Access Compliance Report

Public Rights-of-Way (Curb Ramps)

Intersection ID: 2787	Main Street: RIDGE_PEAK_CT	Cross Street: SKYLINE_DR	Location: SE
ADA ID: F448DC7C56AD	Ramp Type: PerpDiag	Initial Pass/Fail: Fail	Overall Compliance: No
Codes/Mitigation Info/Possible Solution		Field Measurements/Component Compliance	
Severity Score: 22.5

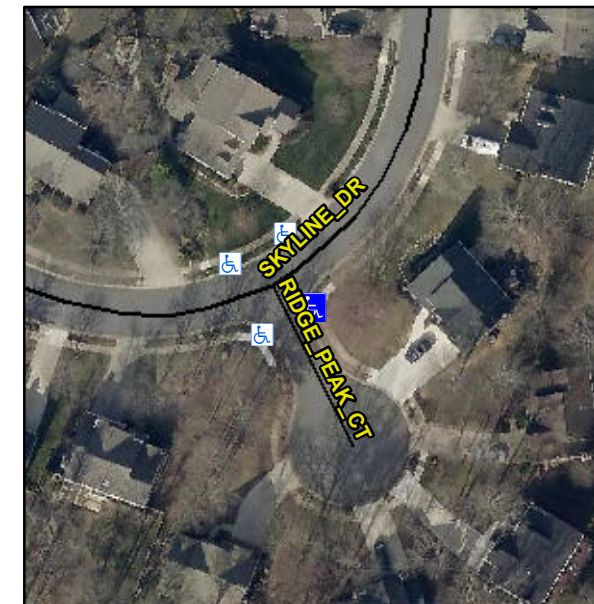
Not Found, R304.5.1, R304.2.2, R304.5.3

Compliance	Description	Data	Compliance	Description	Data
N/A	Ramp Length (in)	48.0	No	Ramp Slope (%)	9.0
No	Ramp Width (in)	39.0	No	Ramp XSlope (%)	3.7
N/A	Flare Type LT	N/A	N/A	Flare Type RT	N/A
N/A	Flare Slope LT (%)	N/A	N/A	Flare Slope RT (%)	N/A
N/A	Flare Traversable LT?	N/A	N/A	Flare Traversable RT?	N/A
N/A	Landing Length (in)	N/A	N/A	DWS Provided?	N/A
N/A	Landing Width (in)	N/A	N/A	DWS Contrast?	N/A
N/A	Landing Slope (%)	N/A	N/A	DWS Length (in)	N/A
N/A	Landing X Slope (%)	N/A	N/A	DWS Full Width?	N/A
N/A	Landing Curb? (Y/N)	N/A	N/A	DWS Offset (in)	N/A
N/A	Shared Landing?	N/A			
N/A	Gutter Ponding?	N/A	N/A	Gutter Slope (%)	N/A
N/A	Gutter Lip Ht (in)	N/A	N/A	Gutter X Slope (%)	N/A
N/A	Painted X Walk1?	No	N/A	Painted X Walk2?	No
	X Walk 1 Direction	To N		X Walk 2 Direction	To W
N/A	X Walk 1 Width (in)	N/A	N/A	X Walk 2 Width (in)	N/A
	X Walk 1 Slope (%)	1.0		X Walk 2 Slope (%)	1.7
	X Walk 1 X Slope (%)	2.3		X Walk 2 X Slope (%)	2.9

Remove & Replace Curb Ramp With Two New Directional Ramps or Equivalent.
